**TECHNICAL BULLETIN****Z04 pads for M4 calipers SUPERSESSION**

1) **107A48649**                      Z04 pad KIT (2 pads included)

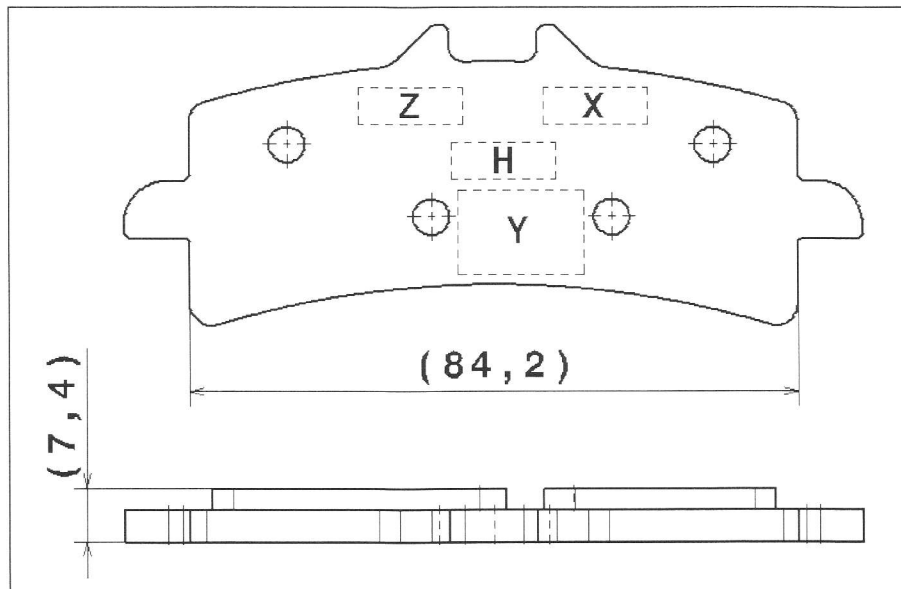
we would like to inform you that the Z04 pad kit 107A48649 has been superseded by the new **107A48639**;

The kit 107A48649 is no longer available in stock;

- Pad total thickness: 7,4 mm;
- Back plate thickness: 4,8 mm;
- **Usable material: 2,6 mm;**
